Hera Sweaters Ltd.

Pechain, Jampur, Sonargaon, Narayanganj
(23.748314N, 90.584084E)

27th January and 8th March 2020

Observations

Inconsistency in as-built drawing

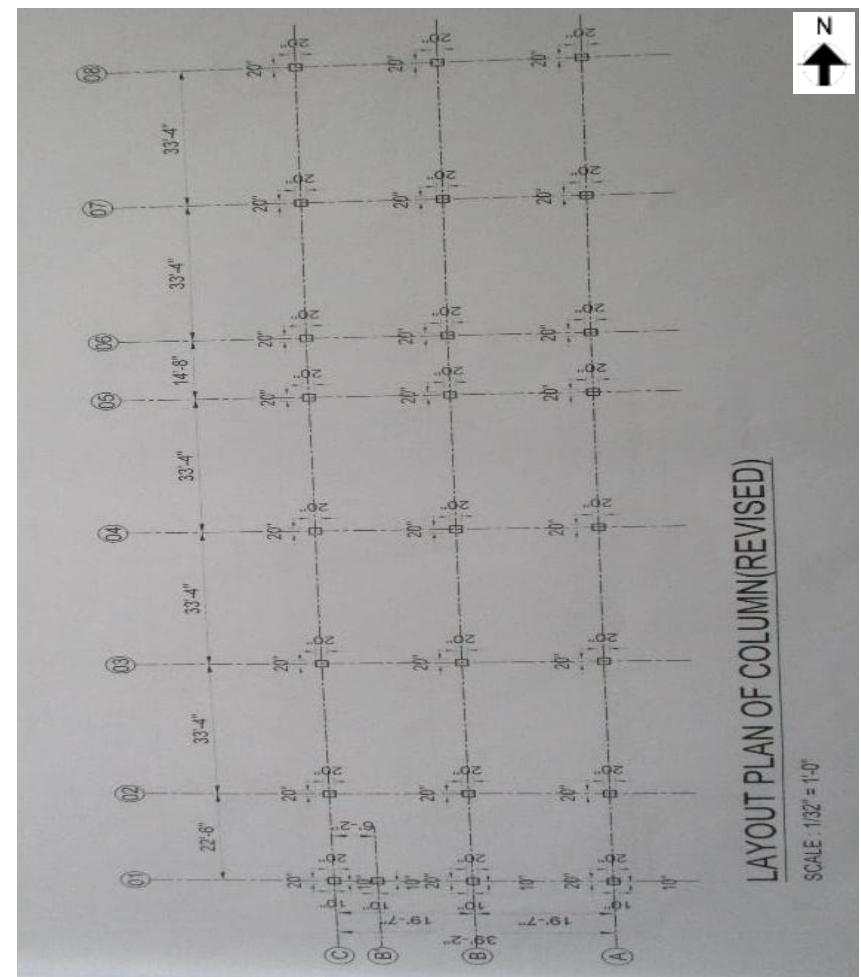
In schedule column types were shown

In layout column indications were not shown

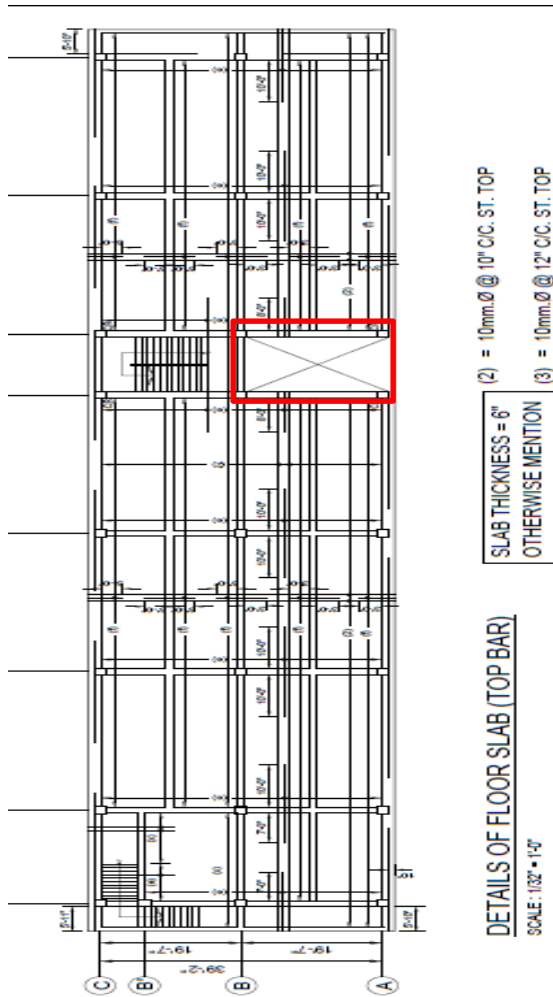
In column layout column type/indication was not mentioned therefore there was an ambiguity to indicate the actual column type in onsite condition. Factory engineer is required to update the as-built drawing showing all the column type.

Portion of slab at staircase was not shown in Slab layout

Factory engineer is required to update the as-built drawing as per onsite condition

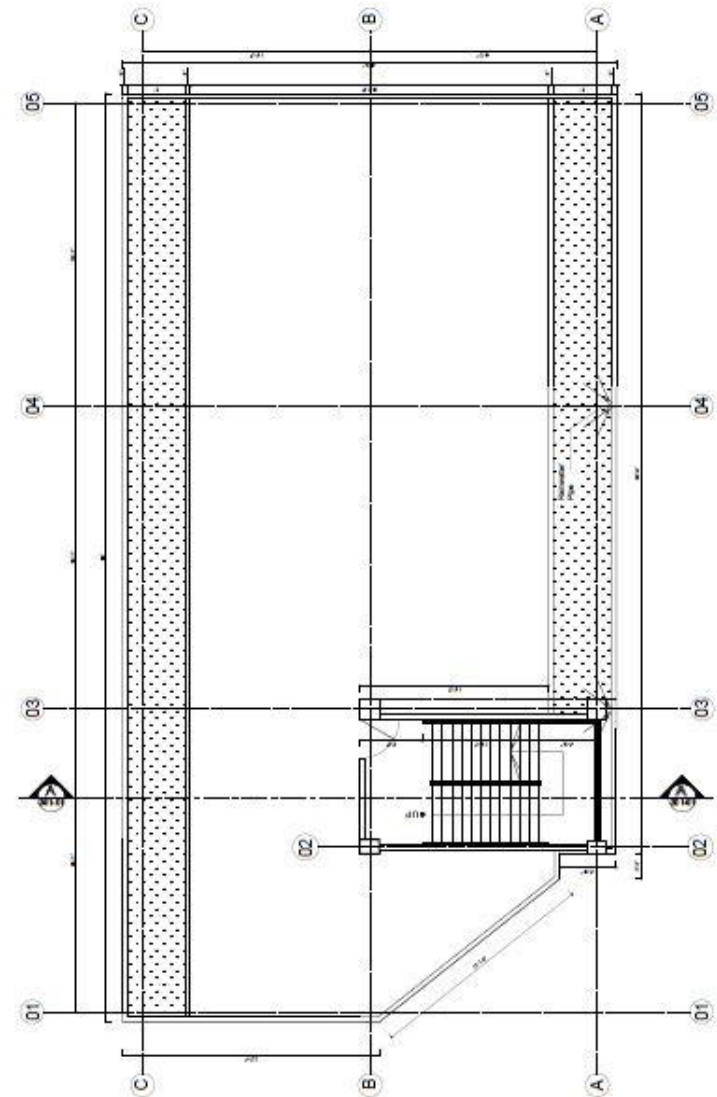
Roof plan was not incorporate in provided drawing. Three 1000-liter plastic water tanks were found on roof slab at north end which were not shown in drawing.

Two plastic water tanks and a tower (each of 1000 liter) were found on roof slab.

Water tanks and tower were not shown in drawing

Factory engineer is required to update the as-built drawing as per onsite condition.

Load plan doesn't comply with BNBC standard

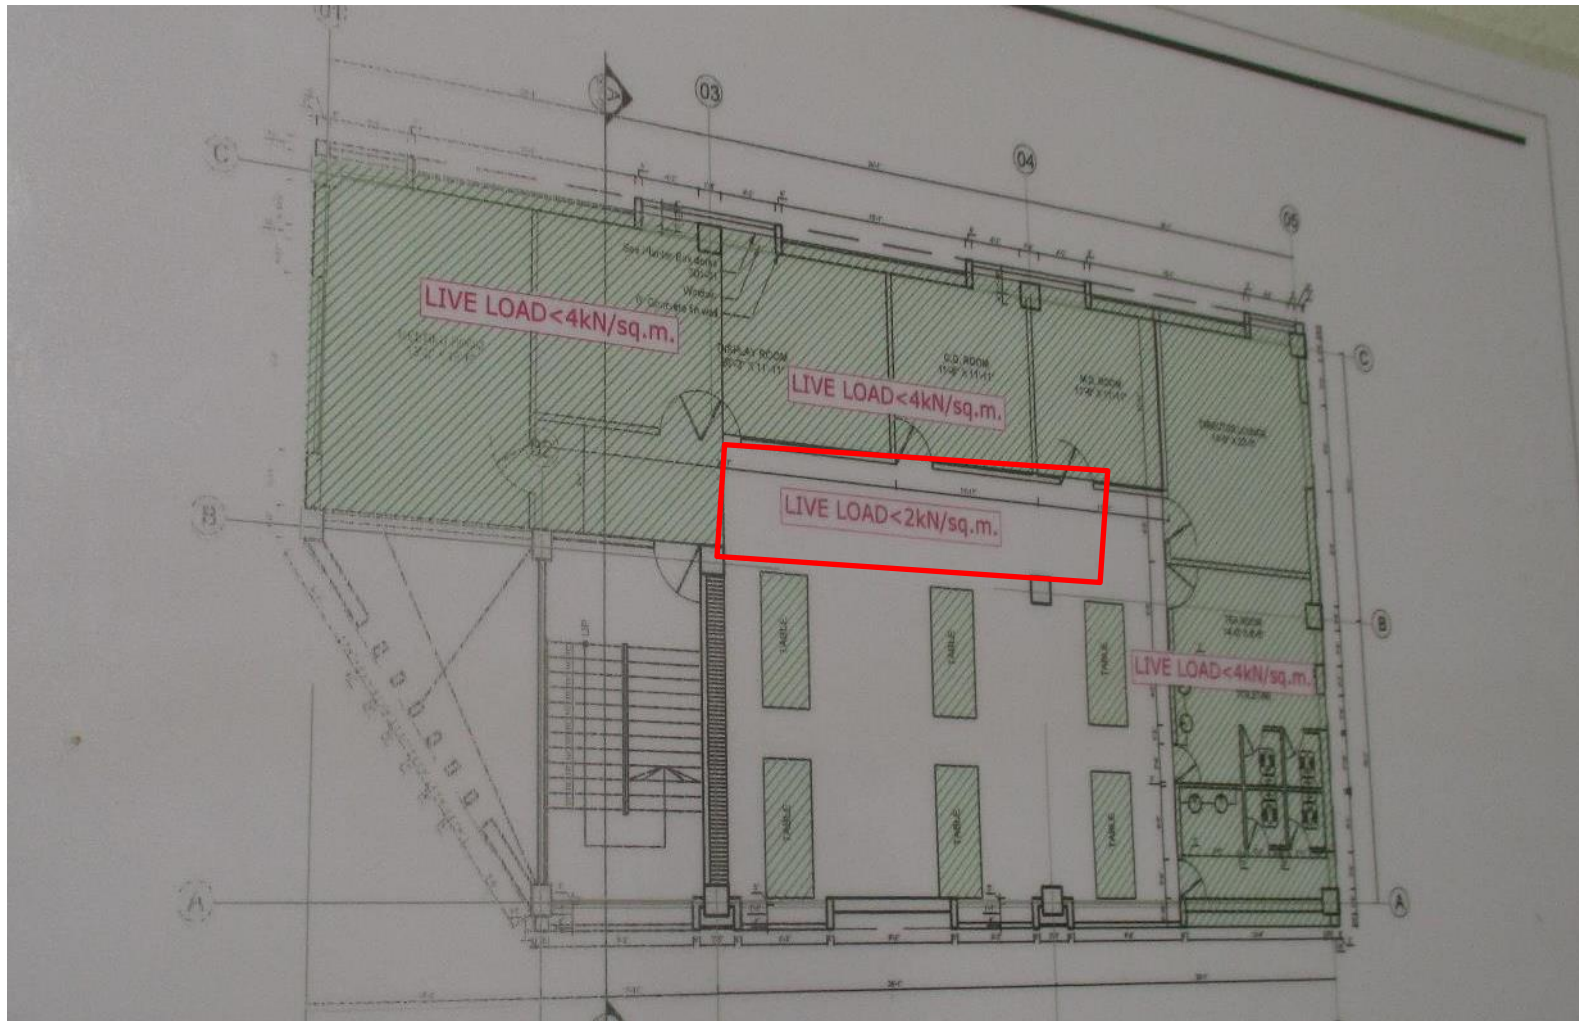
Live load was mentioned as 2 KN/m² for some places in posted load plan

Live load was mentioned as 2 KN/m² for some places in posted load plan. which doesn't comply the BNBC standard. Factory engineer is required to Produce load plan as per BNBC standard.

Crack in brick wall

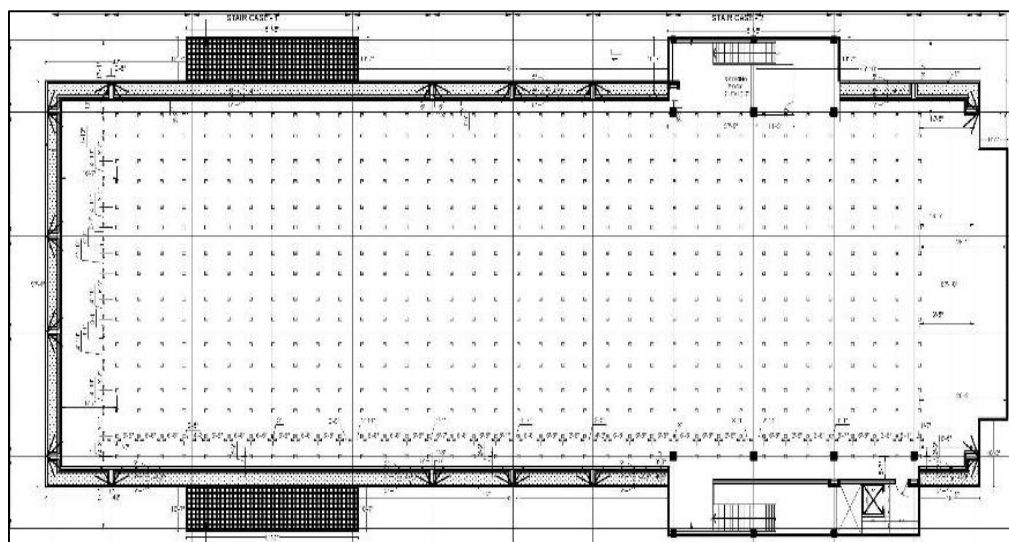
Crack was found in brick wall at ground floor cantilever area (north end)

Factory engineer is required to investigate the cause of crack and repair with a suitable method.

Water tank location in the roof

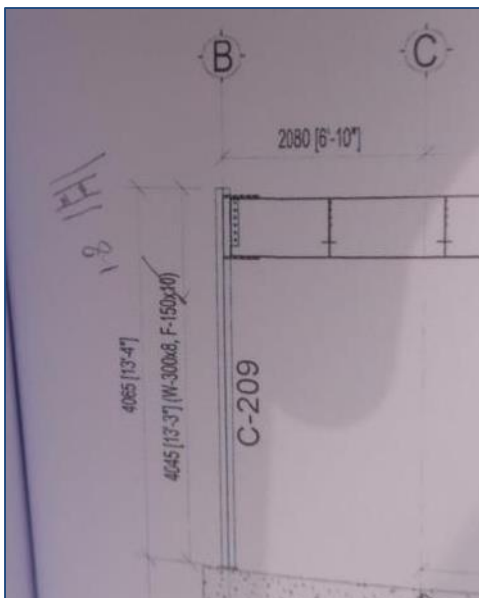
Water tank is not shown in the provided drawing

**Improper Connection, missing bolt and Gap
between member in all steel stairs**

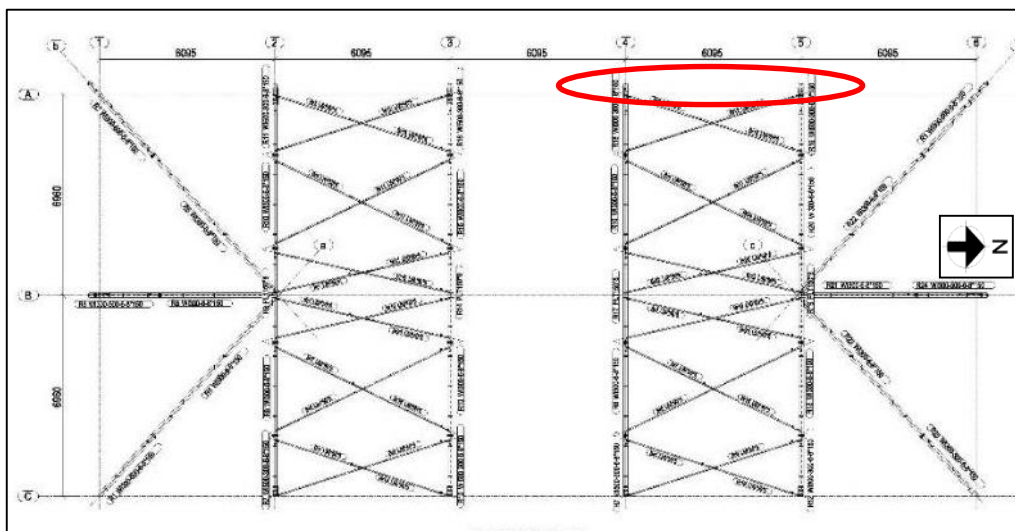
Significant gap found at connection plate joint and RC member. In some places, the connection was found with brick wall. Missing bolt was found in several places. Connections were not constructed as per drawing in several places.

Missing bolt

Improper connection

Gap in connection

Bolt found missing, Significant gap was observed. Apparently, load bearing, and transfer capacity is reduced.
